UNITED STATES
DEPARTMENT OF THE INTERIOR
BUREAU OF LAND MANAGEMENT

SUNDRY NOTICES AND REPORTS ON WELLS

1. Type of Well ☐ Oil Well ☒ Gas Well ☐ Other		5. Lease Serial No. NMNM012292
2. Name of Operator ConocoPhillips Company		6. If Indian, Allottee or Tribe Name 1: 09
3a. Address 5525 Highway 64, NBU 3004, Farmington, NM 87401	3b. Phone No. (include area code) 505-599-3454	7. If Unit or CA/Agreement, Name and/or No. NM
4. Location of Well (Footage, Sec., T., R., M., or Survey Description) Unit p (SESE), 700' FSL & 700' FEL Section 3, T30N, R6W		8. Well Name and No. SJ-31-6 Unit #203A
		9. API Well No. 307039-27469
		10. Field and Pool, or Exploratory Area Basin Fruitland Coal
		11. County or Parish, State Rio Arriba, NM

Due to problems with the planned BOP Key Energy was using, ConocoPhillips needs to change the BOP configuration initially submitted to the following:

For Drilling to Intermediate Casing Point & Setting 7" Intermediate Casing

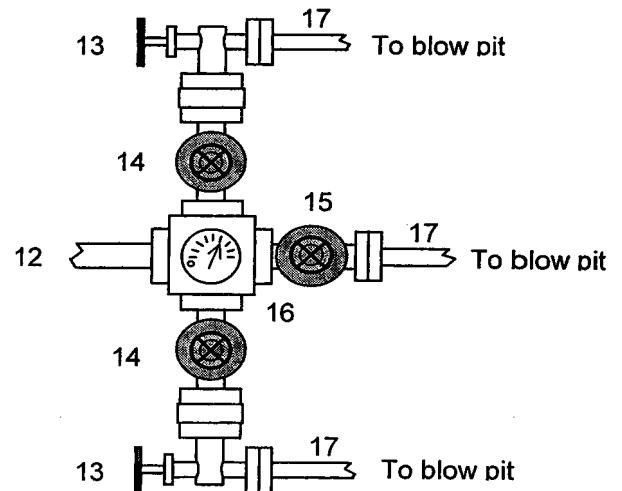
- Change in BOP to a double ram instead of an annular and single ram
- To request an exception to Onshore Order #2 to
 - Allow us to test our BOP and 9-5/8" surface casing to 1000 psi in lieu of Onshore Order #2 requirements
 - Allow us to test our BOP and 7" casing (for the cavitation program) to 1800 psi in lieu of Onshore Order #2 requirement.

This BOP arrangement is for the drilling operations from the time the 9-5/8" surface casing is set through the setting of the 7" intermediate casing. The Casing Head "A" Section will be screwed onto the 9-5/8" surface casing stub. The BOP will be installed on the Casing Head "A" Section. The Pipe Rams, Blind Rams, Choke Manifold, and 9-5/8" surface casing will be tested to a low pressure test of 200 psi to 300 psi and to a high pressure test of **1000 psi** (this value is 44% of the minimum internal yield pressure of the 9-5/8" casing). We will drill the 8-3/4" hole to intermediate casing point and run and cement the 7" intermediate casing. Then we will nipple down the BOP, install a trash cap, & move out the drilling rig. We will install the casing spool on the 7" stub after the drilling rig is moved off location. At a later date we will move in the cavitation rig for the cavitation program.

For Cavitation Program

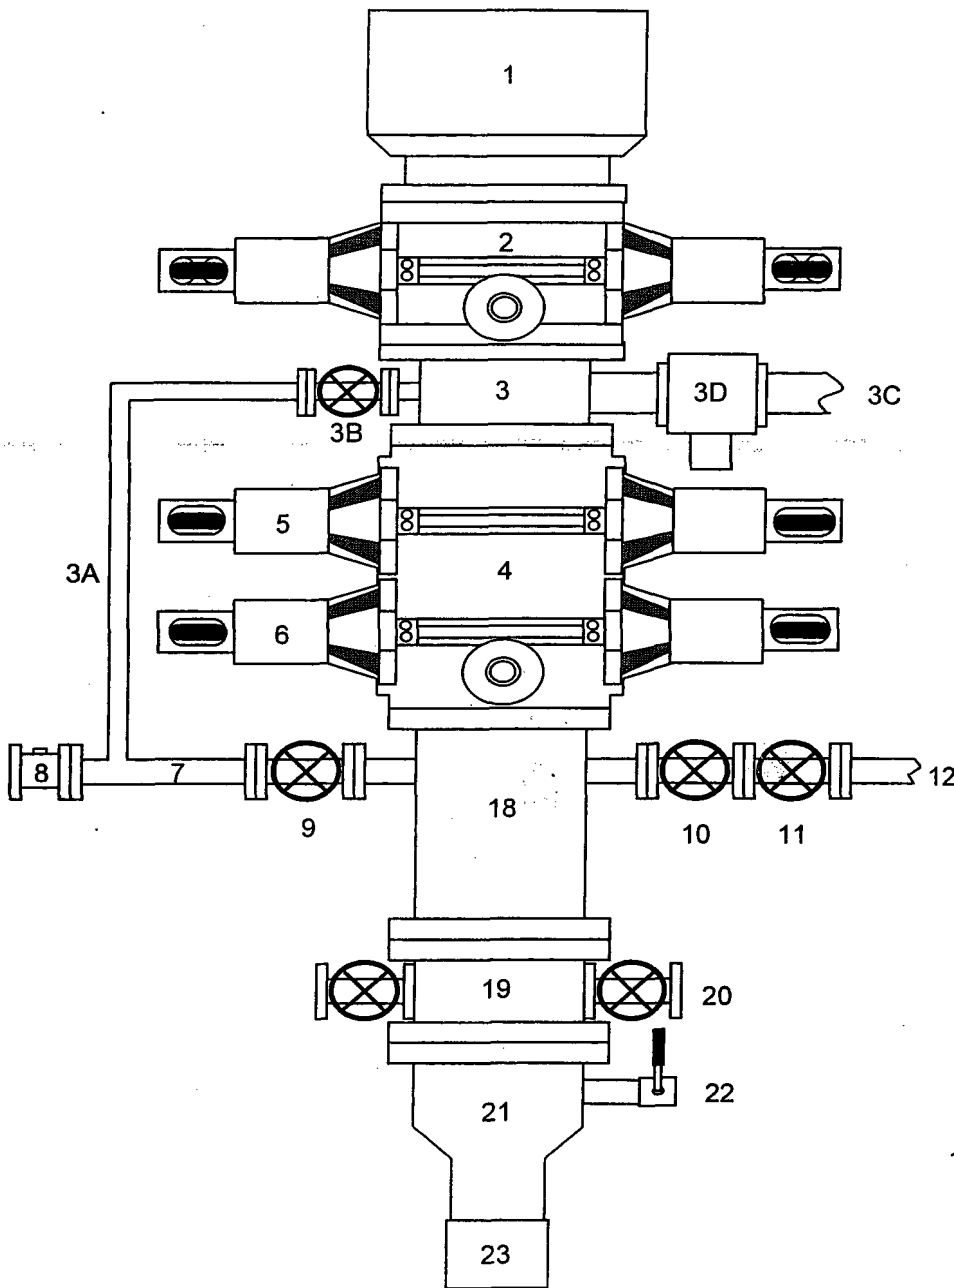
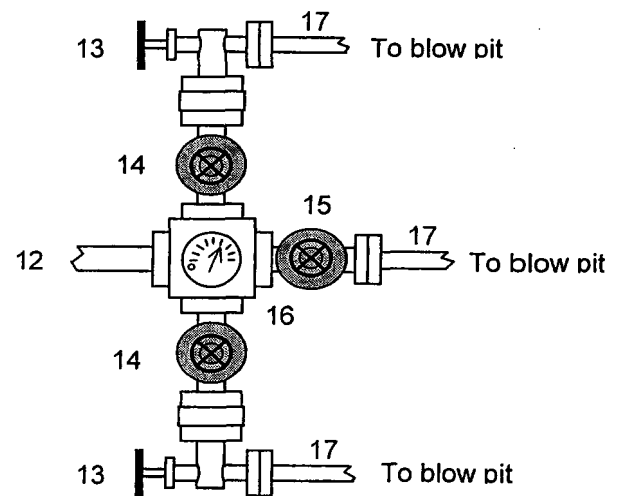
This BOP arrangement and test program is for the cavitation program. The BOP will be installed on the tubing head. The 7" casing will be pressure tested against closed blind rams to 200 psi to 300 psi for 2-3 minutes and to 1800 psi for 30 minutes - this test pressure is 48% of the minimum internal yield strength of 3740 psi for the 7", 20#, J-55, STC casing. The pipe rams and choke manifold will be tested to 200 psi to 300 psi (low pressure test) for 2-3 minutes and to 1800 psi (high pressure test) for 10 minutes - This test will be done with a test plug or possibly without a test plug (ie against casing). If we conduct this test without a test plug we will ensure that we have sufficient drillstring weight in the hole to exceed the upward force generated by the test.
